**Design Review Board Case #2019-0001**  
**WMATA Building - Block 15A / 2395 Mill Road**

Application	General Data	
<p><b>Project Name:</b> WMATA Office Building – Block 15A</p> <p><b>Location:</b> 2393, 2395, 2403, 2415, &amp; 2421 Mill Road</p> <p><b>Applicant:</b> WMATA c/o McGuireWoods LLP</p>	<b>DRB Date:</b>	September 26, 2019
	<b>Site Area:</b>	3.116 acres (135,737 sf)
	<b>Zone:</b>	OCM(100) & UT to CDD#2 & UT
	<b>Proposed Use:</b>	Office Building
	<b>Gross Floor Area:</b>	425,187 SF
<p><b>Purpose of Application:</b> Final design review of the landscaping and site signage for an approved new 14-story office building with above-grade parking. This is the fourth review of the proposed project.</p>		
<p><b>Staff Reviewers:</b> Robert M. Kerns, AICP <a href="mailto:robert.kerns@alexandriava.gov">robert.kerns@alexandriava.gov</a>  Thomas H. Canfield, AIA <a href="mailto:tom.canfield@alexandriava.gov">tom.canfield@alexandriava.gov</a>  Dirk H. Geratz, AICP <a href="mailto:dirk.geratz@alexandriava.gov">dirk.geratz@alexandriava.gov</a>  Abigail Harwell <a href="mailto:abigail.harwell@alexandriava.gov">abigail.harwell@alexandriava.gov</a></p>

## I. OVERVIEW

Image 1: DRB Submitted Ground Floor Plan

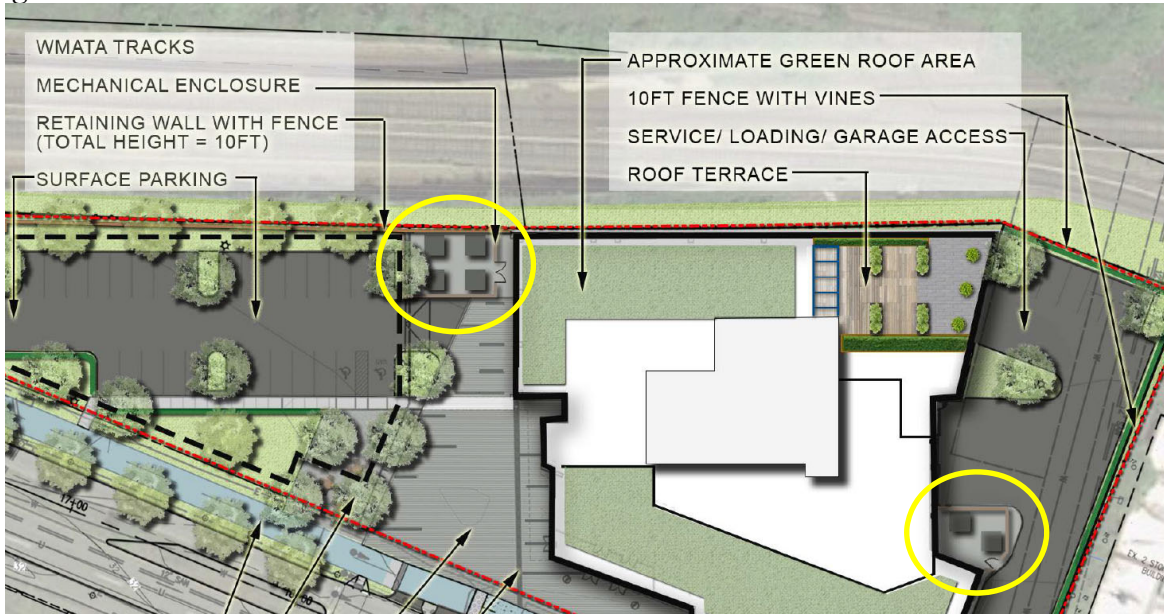
The landscape plans proposed have minimally changed since the versions last presented to the DRB in July. The main entry plaza area coming off the intersection of Mill Road and Mandeville Lane continues to integrate horizontal, decorative pavers for the area between the building and the asphalt surface parking lot. Separation of the plaza into driveway and pedestrian areas is proposed to be accomplished by means of six inch diameter bollards. On the west side of the plaza, between Mill Road and the surface parking lot, three sets of tables and chairs will provide a seating area adjacent to the new multimodal path running in front of the property along Mill Road.

There are two transformer areas indicated on the plans: one area on the west side of the building, at the end of the main entrance driveway, and a second area on the east side of the building, adjacent to the loading bays. More information has been provided regarding these enclosures, including design and material solutions. It should be noted that there is a discrepancy between the plans submitted for DRB review and the plans submitted to Staff for Final Site Plan Review, as shown on Exhibit A. The wall surrounding the equipment is to measure 8'-4" tall with hollow metal doors. The material is proposed as a stucco finish, in a color to match the precast of the building. No landscape screening is proposed for either enclosure due to spacing constraints. Staff had asked the applicant to provide additional vegetative screening to soften the appearance of the enclosure walls, with either vines or additional greenery. The applicant has declined to provide this, citing shade concerns and security requirements.

Image 2: Final Site Plan Drawings – Transformer Locations and Elevations (Sheet A203)

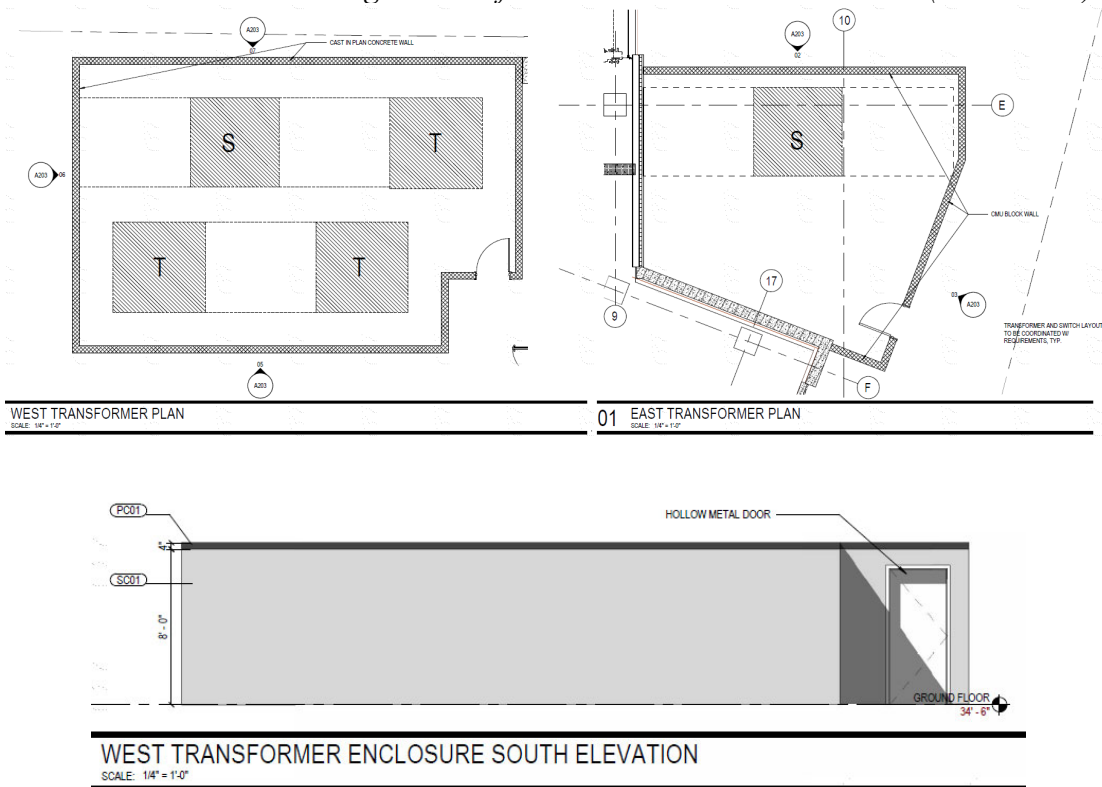
In discussing these enclosures, it should be noted that, while the enclosure on the east side of the building will be minimally visible, the one on the west, sitting as it does directly on axis with the pedestrian and vehicular entry, is visually extremely prominent. At 30 by 40 feet in size, the enclosure is essentially a small building. Since the previous submission, it has been moved to the east, resulting in an unattractive and virtually unmaintainable gap of approximately 18 inches between it and the exterior wall of the office building. A notch has also been cut out of the southeast corner of the enclosure for an access door, which faces the main entry to the site and further draws attention to the uncomfortable juxtaposition of building and transformer enclosure.

While staff would strongly prefer a solution that relocated the west transformer yard to the east side of the building (potentially in lieu of the six parking spaces shown near the garage entrance), applicant has explained that existing easements preclude that option.

Given the above, staff feels that the best solution for mitigating the impact of the west transformer enclosure is to treat it as an extension of the office building. Staff recommends using the two adjacent building materials to form the south and west walls of this enclosure – specifically, the stone base (which is approximately four feet tall at this location) combined with the office building façade louver system for the top half of the wall. For the access doors to the enclosure, staff recommends locating them in the middle of the south or west façades. This treatment effectively eliminates the east side of the enclosure, and leaves a single wall facing the rail corridor that could be treated more simply. Staff has provided an exhibit illustrating this concept, simply using elements of the proposed building façade ( EXHIBIT B).
